# Development Review Team Memo

**RE:** PL20240103, Ski Hill Subdivision Replat of Parcel D, Lot 2 (1965 Ski Time Square Drive)

Mountain Area Master Plan, 2022

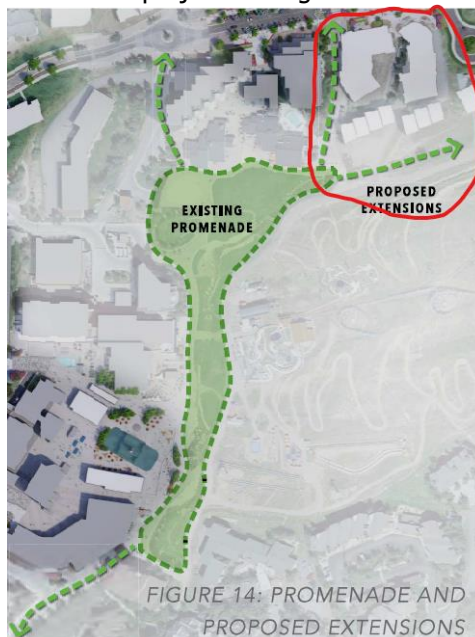
2. The existing conditions map identifies tracts F1 and D1 as separate parcels but they are not specifically called out as part of the proposed PP.
3. The URA goals and objectives include enhancing the safety of the visitor and pedestrian experience in the mountain base area. The 2022 Mountain Area Master Plan identifies pedestrian connections between the existing promenade and Ski Time Square Drive in the area of this development parcel (see below). At time of development plan the applicant should include a public pedestrian connection along the Burgess Creek corridor and include dedication language in the final plat. The easement shall be 25-ft minimum and dedicated for public use. The design will be further evaluated as part of the development plan review.
